ROAD SAFETY AUDIT

NEW PARK AVENUE: WEST HARTFORD PLACE (HOME DEPOT PLAZA) TO PROSPECT AVENUE

November 2025

Exhibit 5: Corridor Recommendations - South

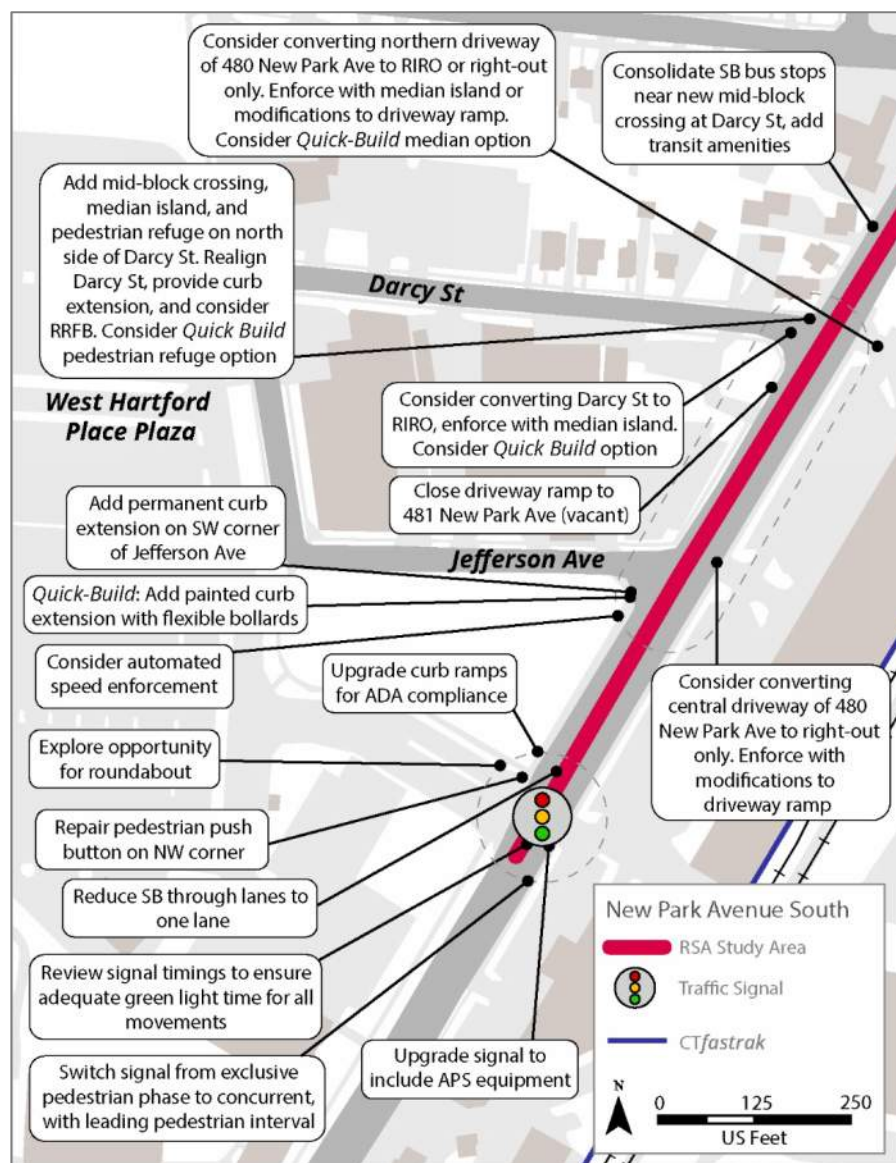
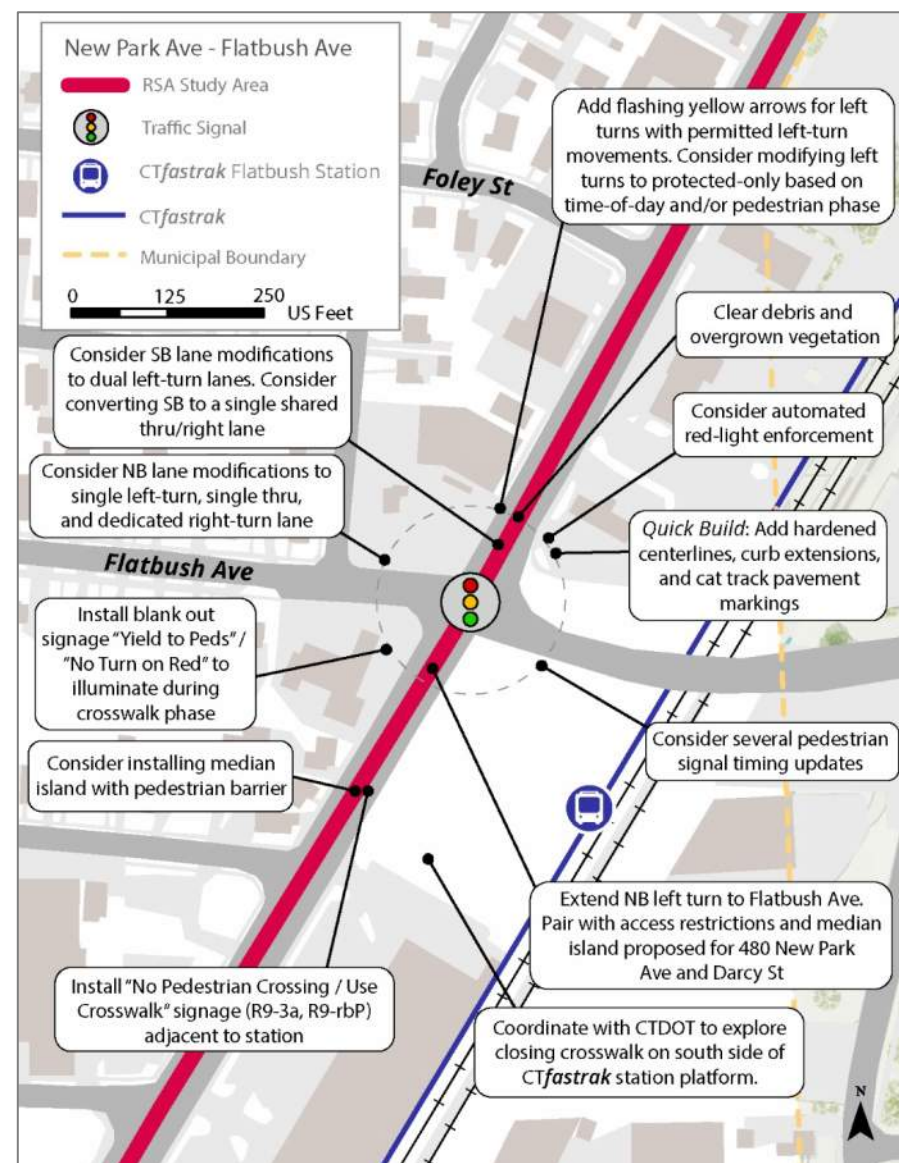
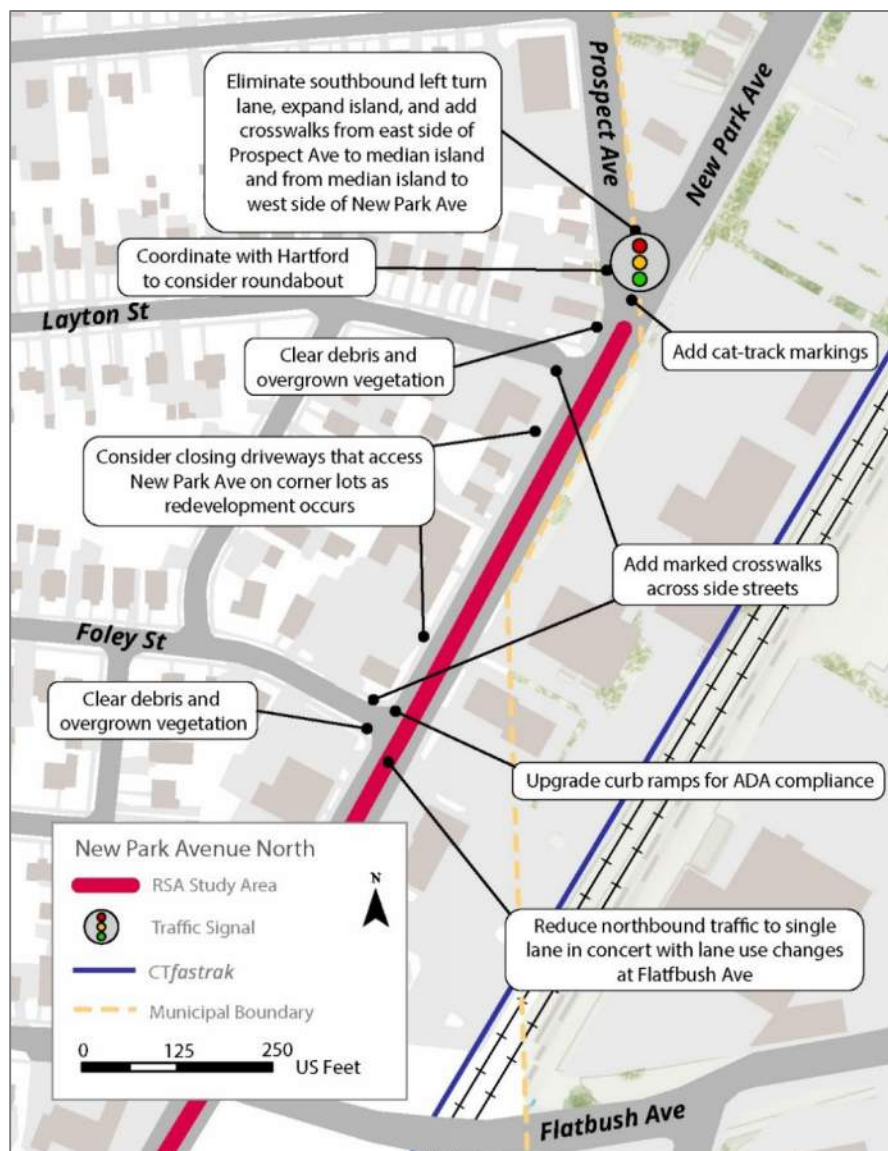
- Install retro-reflective backplates on all traffic signals.
- Replace all streetlight fixtures to ensure the lighting meets lumen output recommended by AAHSTO *Roadway Lighting Design Guide* (2018).
- Trim vegetation encroaching on sidewalk and sight triangles.
- Apply to Connecticut Office of the State Traffic Administration (OSTA) for a modification of the speed limit to 30 MPH based on the following:
 1. Recommended speed limit based on FHWA's [*Methods and Practices for Setting Speed Limits*](#) as one recommended method by Connecticut Department of Transportation (CTDOT) OSTA [*Guidelines for Establishing Speed Limits in the State of Connecticut*](#). Reductions in the speed limit are recommended by the methodology because of the number of driveways, pedestrian activity, and crash history.

- Repair sidewalk slabs in need of repair.
- Install decorative pedestrian lighting on the east side of road between West Hartford Place Plaza and Prospect Avenue.

- Connect side path south of West Hartford Place (soon to be under construction) to Oakwood Avenue bike lanes via Jefferson Avenue right-of-way.

- Continue a low-stress bicycle facility (separated bike lanes or side path) along the west side of New Park Avenue to Prospect Avenue. Connect to existing buffered bike lanes in Hartford on New Park Avenue and the proposed bike facility on Prospect Avenue (See Prospect Avenue RSA).

Exhibit 8: New Park Avenue Proposed Cross Section, at Flatbush Avenue Intersection, View North

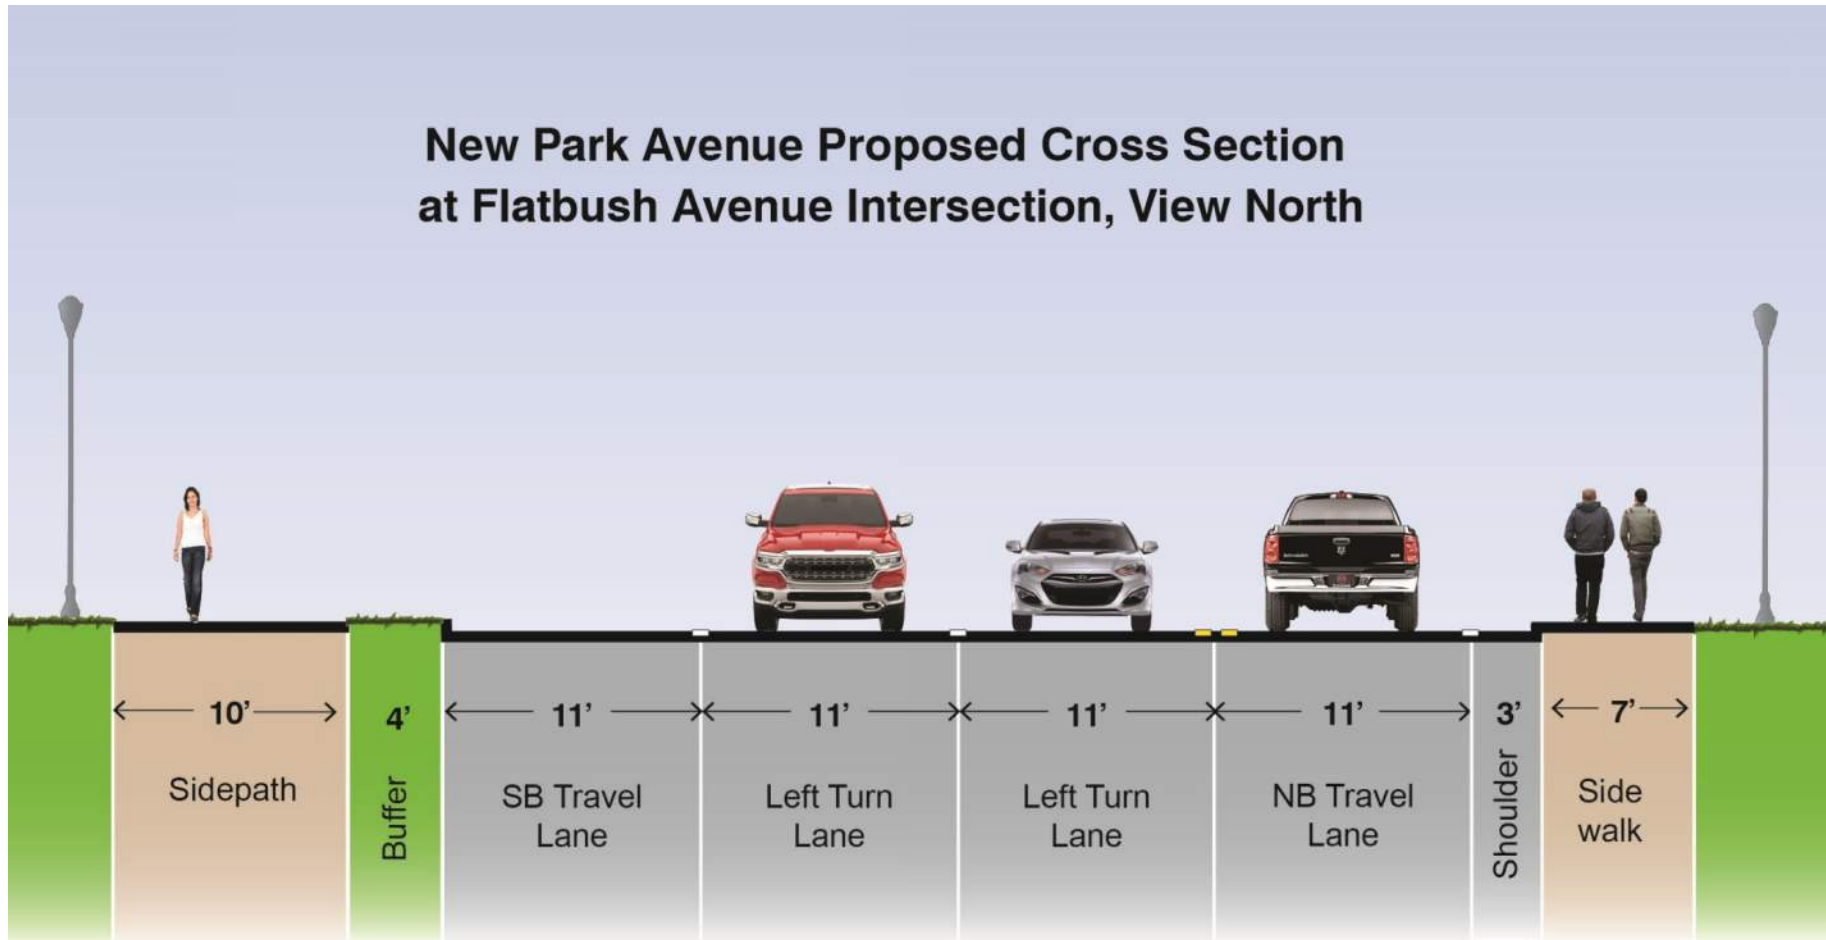
- **Quick-Build:** Add hardened centerlines on all approaches to slow left-turning speeds. Consider curb extensions if feasible with larger vehicle turning movements and plowing operations. Install cat track pavement markings through intersection for turning movements to align with hardened centerlines.
- Install “No Pedestrian Crossing / Use Crosswalk” signage (R9-3a, R9-3bP) adjacent to CT**fastrak** station and opposite station to encourage pedestrians to cross utilizing the pedestrian signal at the Flatbush Avenue intersection. Include Spanish-language text on signage.

- Consider southbound lane modifications to dual left-turn lanes. Consider converting southbound to a single shared thru/right lane to support median island proposed on south side of Flatbush Avenue. This would require additional traffic analysis and protected-only northbound and southbound left-turn.

Exhibit 9: New Park Avenue Proposed Cross Section, North of Darcy Street, View North

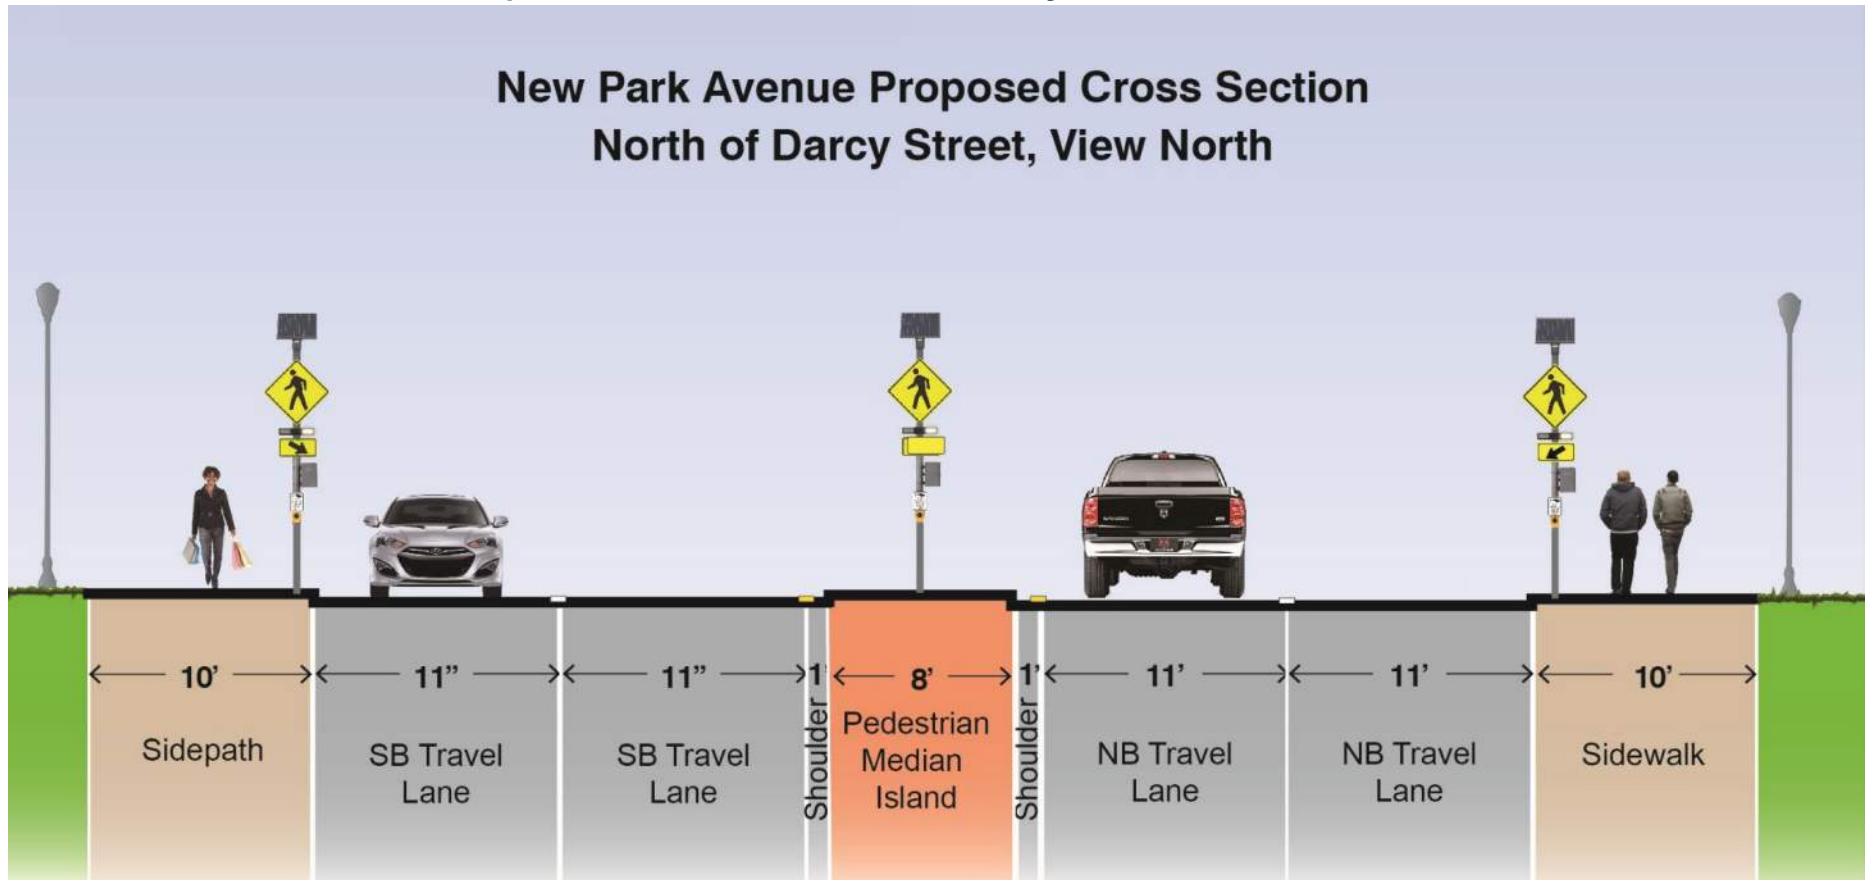
- Consider converting Darcy Street to RIRO only. Enforce with median island. Consider *Quick-Build* median option.
- Add mid-block crossing with median island and pedestrian refuge on north side of Darcy Street. Realign Darcy Street to the south and provide curb extension on northwest corner to accommodate crosswalk. Consider installing a Rectangular Rapid Flashing Beacon. Consider a *Quick-Build* pedestrian refuge option at this location, with the crossing to be considered with a pedestrian refuge and sufficient width.
